Glenilla Road

Material Amendment
05 March 2021

ADAM KHAN ARCHITECTS

Ground Floor Plan - Consented

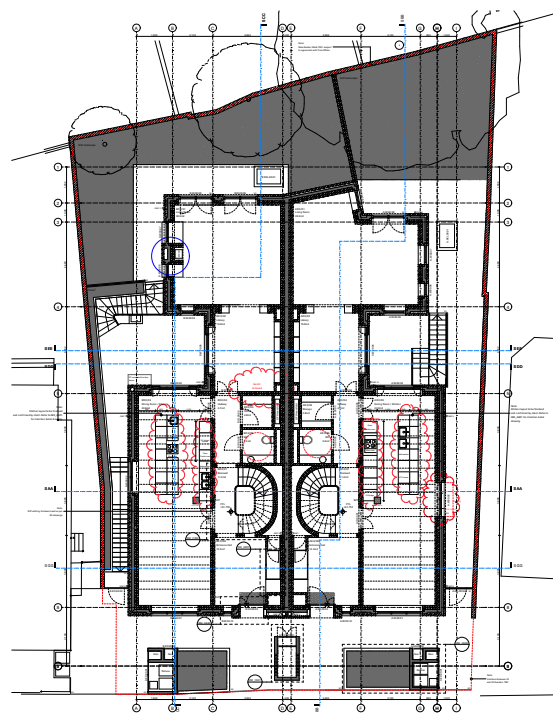
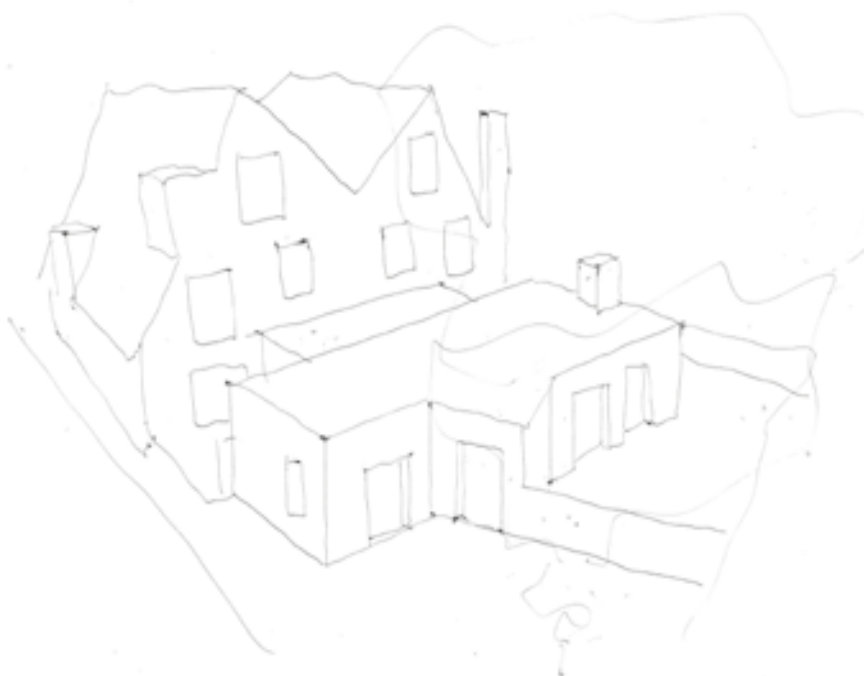
1.1 Ground Floor and Massing

The rear of the house was revised to lessen visual impact and improve the internal qualities of the affected rooms. The slightly irregular geometry is very effective on breaking the massing without relying on height variation as per consented application. The revised position of the wall dividing the two gardens at the back, makes for better gardens and has a more sympathetic relationship with the existing trees.

An additional chimney is added at the rear, helping further break the massing and generate a richer dialogue with the main volume of the house.
